CALL NO. 202
CONTRACT ID NO. 151067
ADDENDUM # 2

Subject: Fayette County, 034GR15D067
Letting October 23, 2015

- (1) Revised - Plan Sheets - R2F, R2H, R2I, R2K, R3, R6, & R9
- (2) Revised - Material Summary - Pages 51-55 of 133
- (3) Revised - Bid Items - Pages 129-133 of 133
- (4) Added - Notes - Pages 1-17 of 17

COUNTY OF	ITEM NO.	SHEET NO.
FAYETTE	7-433.00	R3

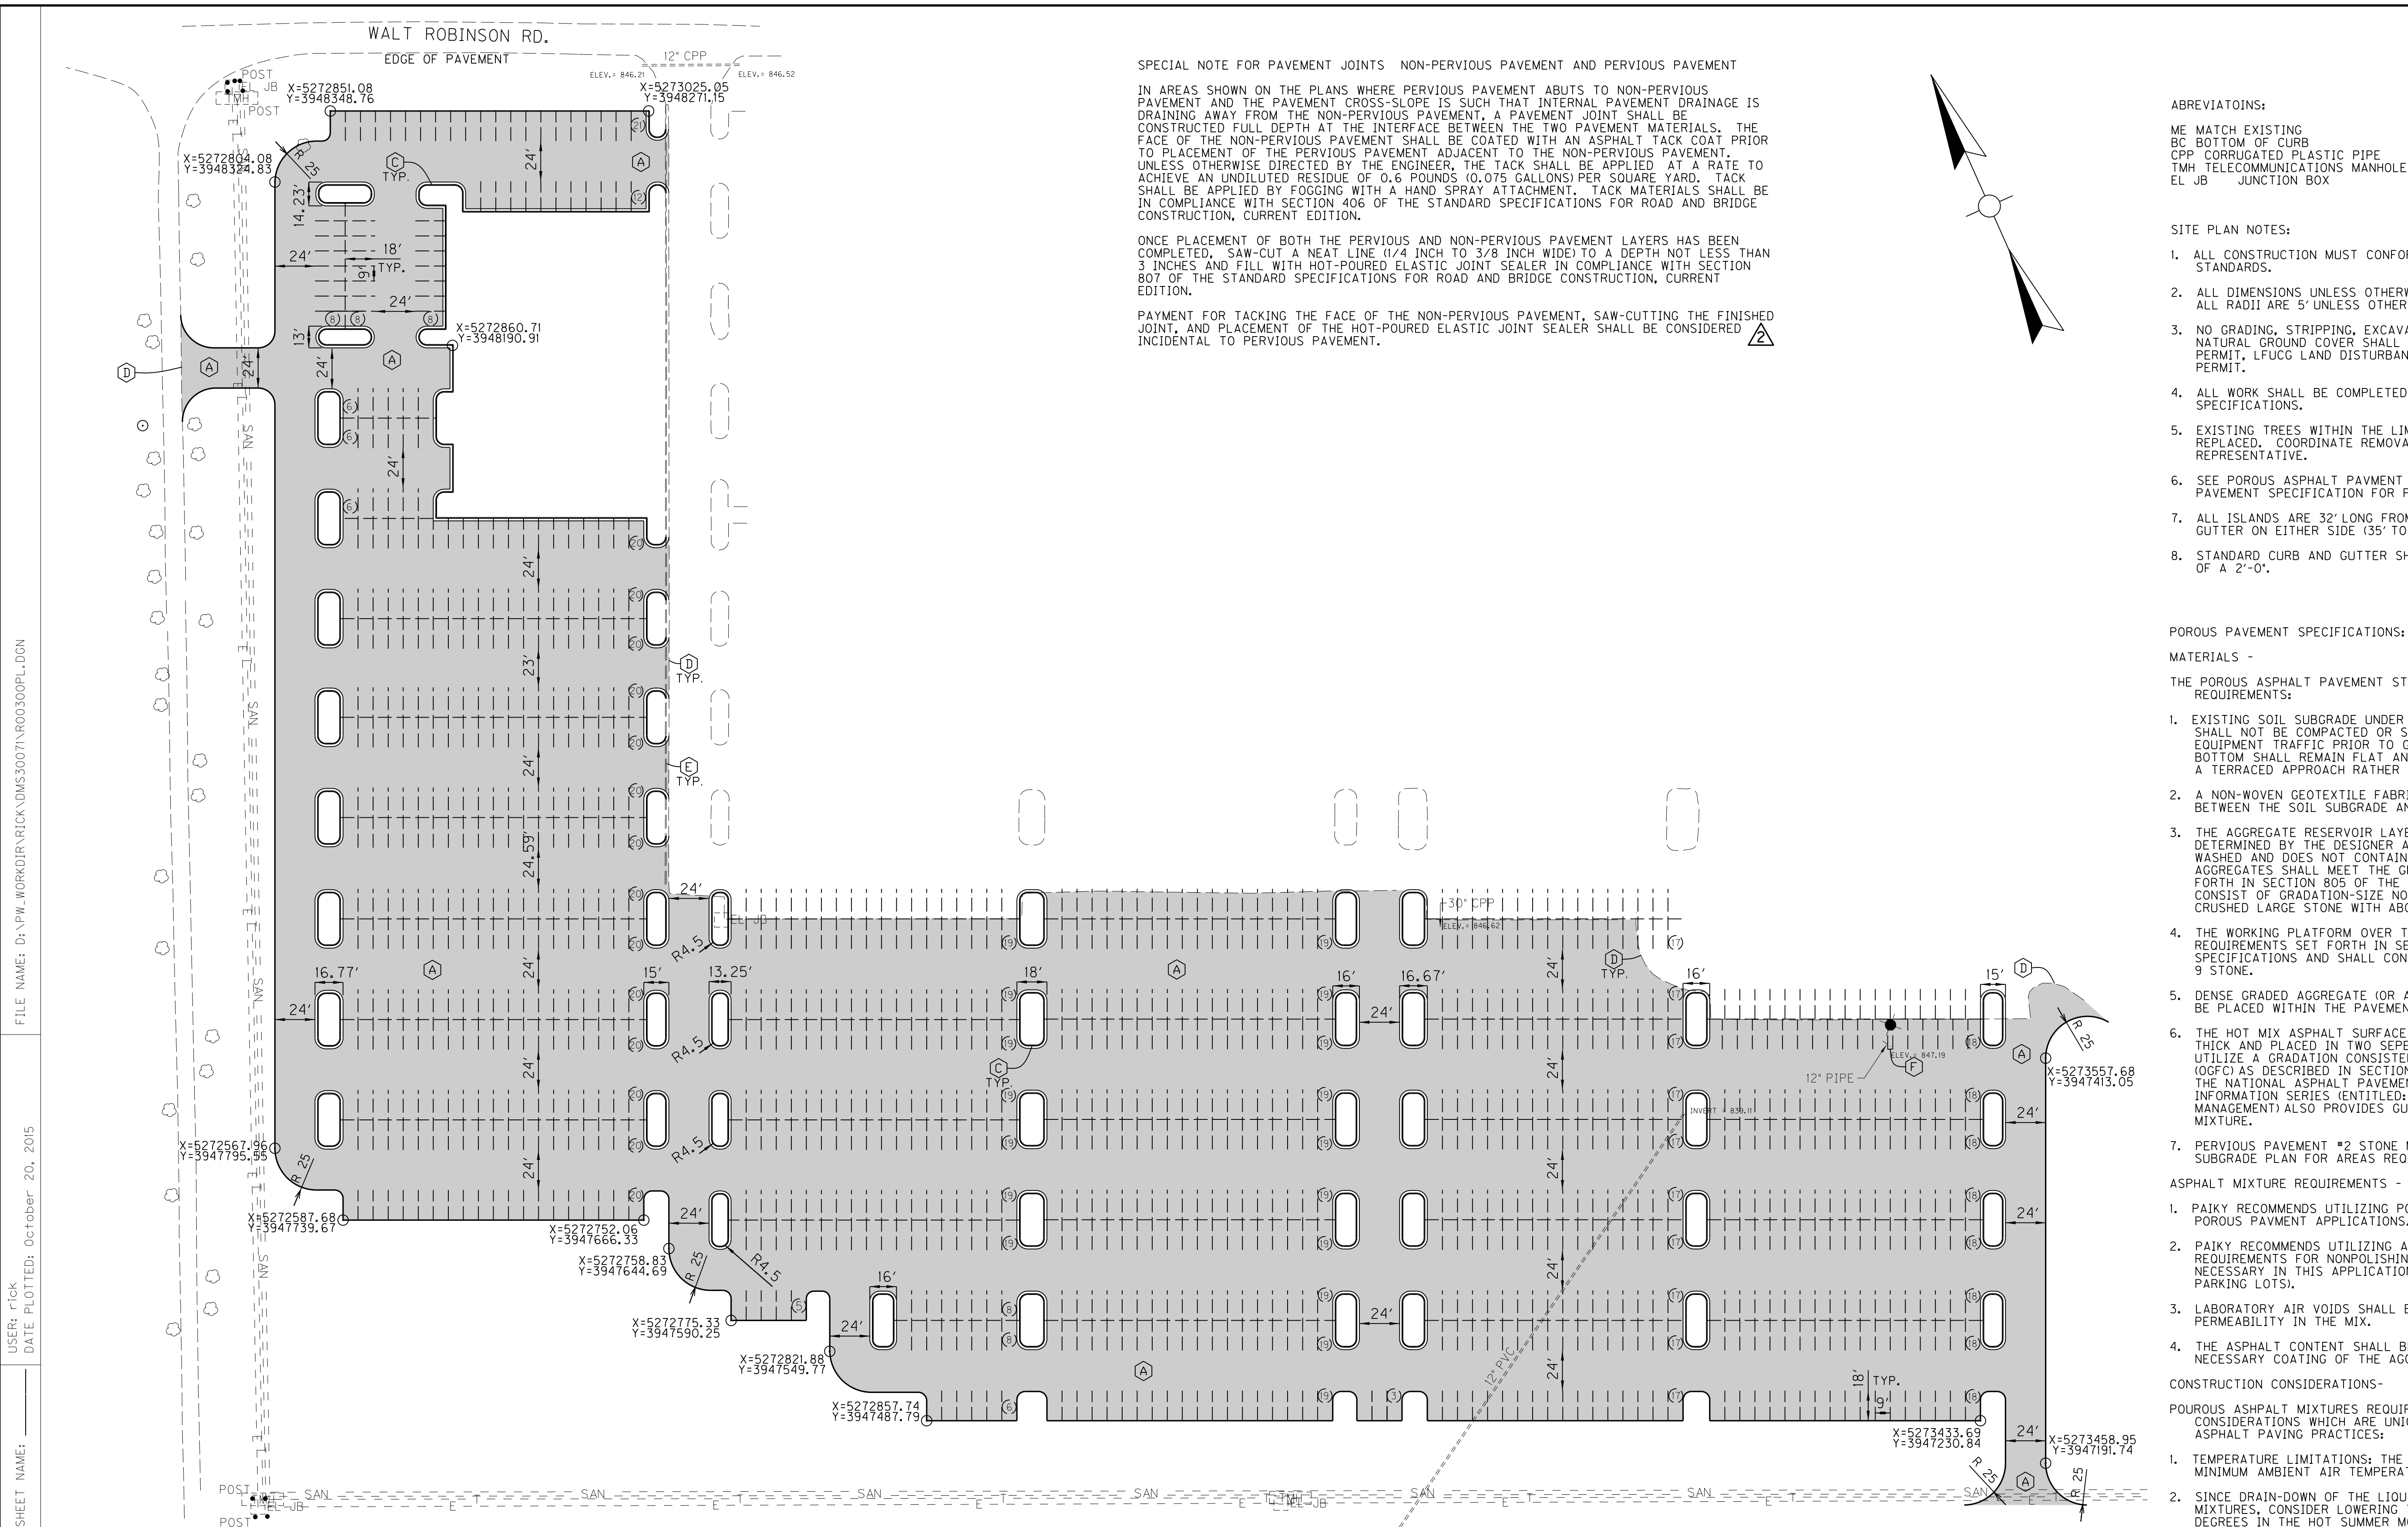
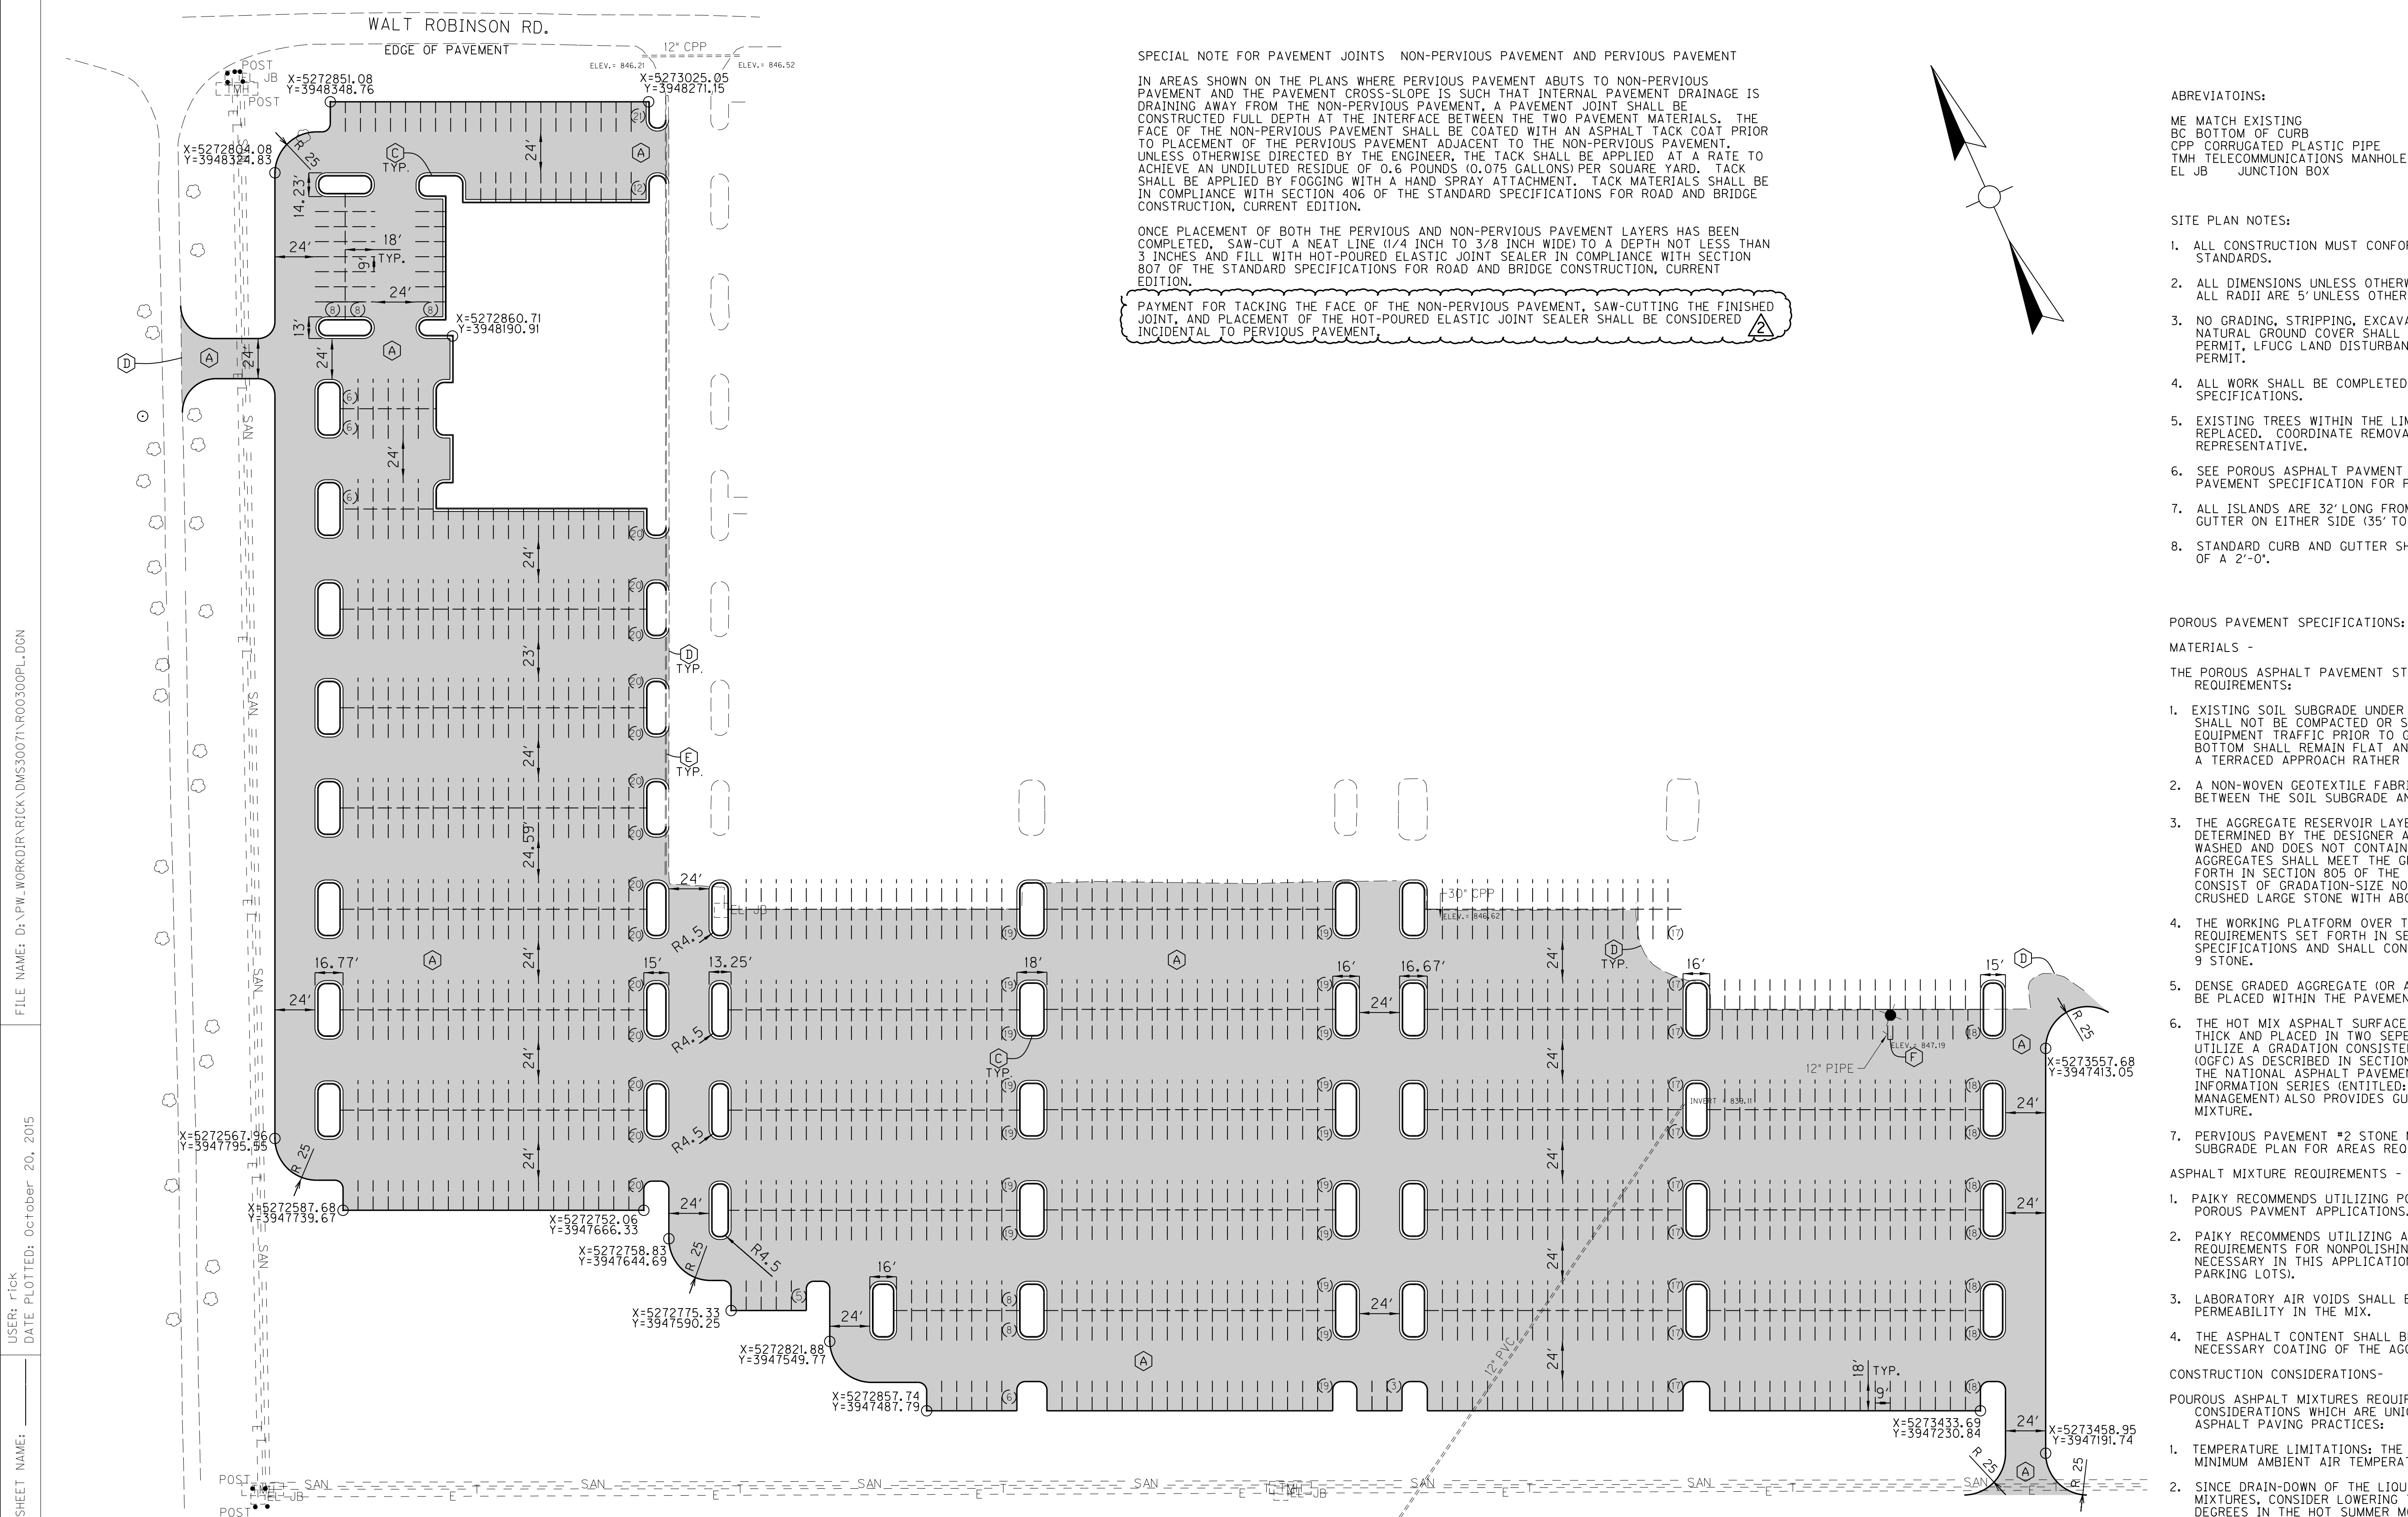
SPECIAL NOTE FOR PAVEMENT JOINTS NON-PERVIOUS PAVEMENT AND PERVIOUS PAVEMENT

IN AREAS SHOWN ON THE PLANS WHERE PERVIOUS PAVEMENT ABUTS TO NON-PERVIOUS PAVEMENT AND THE PAVEMENT CROSS-SLOPE IS SUCH THAT INTERNAL PAVEMENT DRAINAGE IS DRAINING AWAY FROM THE NON-PERVIOUS PAVEMENT, A PAVEMENT JOINT SHALL BE CONSTRUCTED FULL DEPTH AT THE INTERFACE BETWEEN THE TWO PAVEMENT MATERIALS. THE FACE OF THE NON-PERVIOUS PAVEMENT SHALL BE COATED WITH AN ASPHALT TACK COAT PRIOR TO PLACEMENT OF THE PERVIOUS PAVEMENT ADJACENT TO THE NON-PERVIOUS PAVEMENT. UNLESS OTHERWISE DIRECTED BY THE ENGINEER, THE TACK SHALL BE APPLIED AT A RATE TO ACHIEVE AN UNDILUTED RESIDUE OF 0.6 POUNDS (0.075 GALLONS) PER SQUARE YARD. TACK SHALL BE APPLIED BY FOGGING WITH A HAND SPRAY ATTACHMENT. TACK MATERIALS SHALL BE IN COMPLIANCE WITH SECTION 406 OF THE STANDARD SPECIFICATIONS FOR ROAD AND BRIDGE CONSTRUCTION, CURRENT EDITION.

ONCE PLACEMENT OF BOTH THE PERVIOUS AND NON-PERVIOUS PAVEMENT LAYERS HAS BEEN COMPLETED, SAW-CUT A NEAT LINE (1/4 INCH TO 3/8 INCH WIDE) TO A DEPTH NOT LESS THAN 3 INCHES AND FILL WITH HOT-POURED ELASTIC JOINT SEALER IN COMPLIANCE WITH SECTION 807 OF THE STANDARD SPECIFICATIONS FOR ROAD AND BRIDGE CONSTRUCTION, CURRENT EDITION.
